NOTICE OF PUBLIC HEARING
PLANNING COMMISSION
ON
NOVEMBER 15, 2022

THE PLANNING COMMISSION WILL HOLD A PUBLIC HEARING ON TUESDAY, NOVEMBER 15, 2022 AT 6:00 P.M. IN COUNCIL CHAMBERS OF ROCKY RIVER CITY HALL FOR A PUBLIC HEARING FOR THE CONTINUATION OF A PRELIMINARY REVIEW OF A NEW OFFICE BUILDING AT 19933 LAKE RD. FOR SEAN KENNEDY.

RE: Preliminary Planning Commission Submission
Follow up
Project Name: New Office Building
Project Location: 19933 Lake Road
Vocon Project No. 220039.00

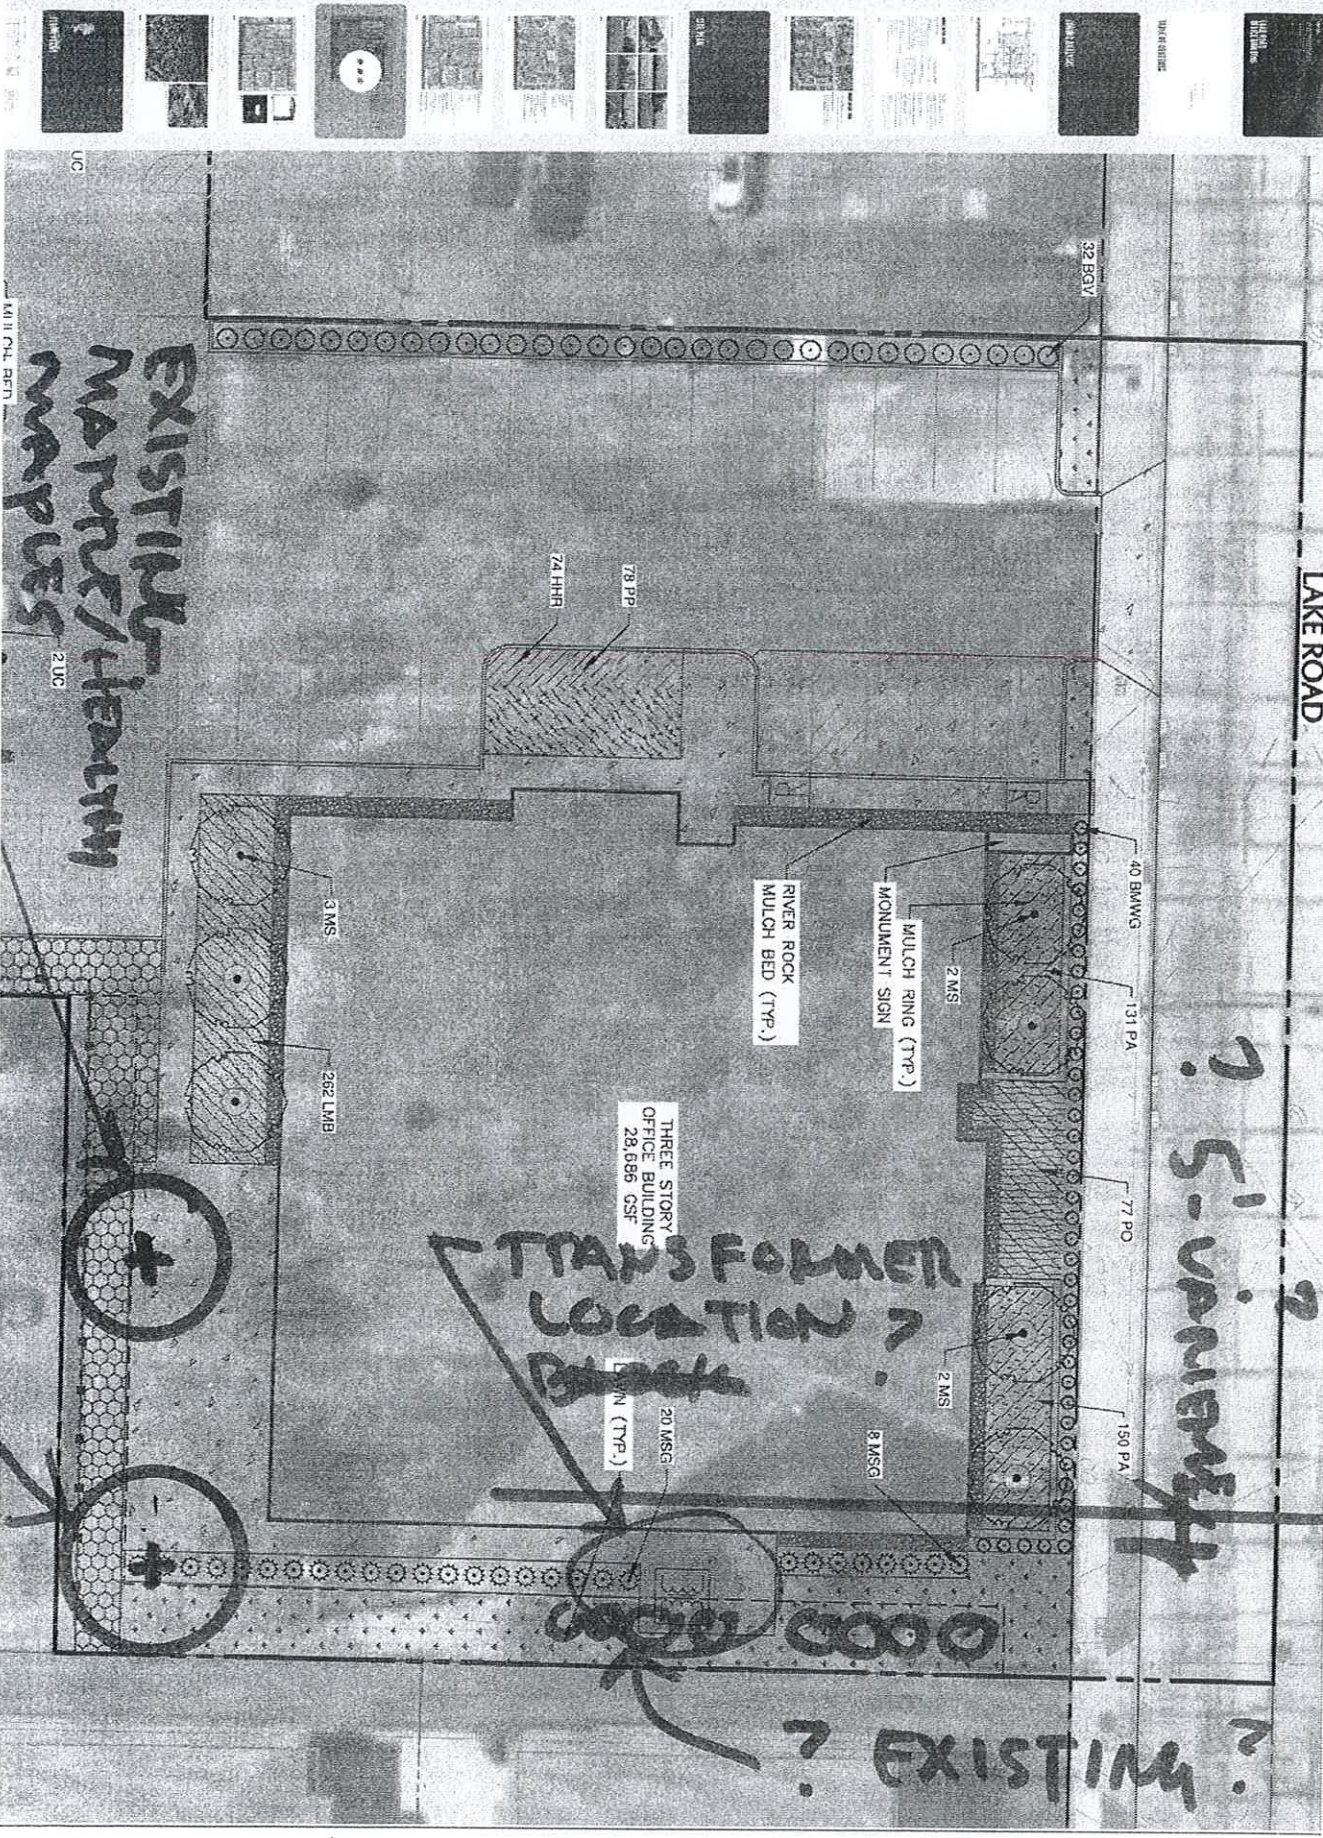
1. 5ft violation on the east side building line.
(A variance has already been granted to the property to the east.)
It compromises the visibility of an existing business.

2. The height variance is very generous; there needs to be a drawing showing the height of the proposed and existing buildings.
3. The site plan shows cutting down all the existing landscaping:
including 2 mature maple trees, a flowering pear tree and a green barrier of 14 arborvitae planted in a landscape easement by the development to the east. There is no landscaping shown to replace these important visual barriers.
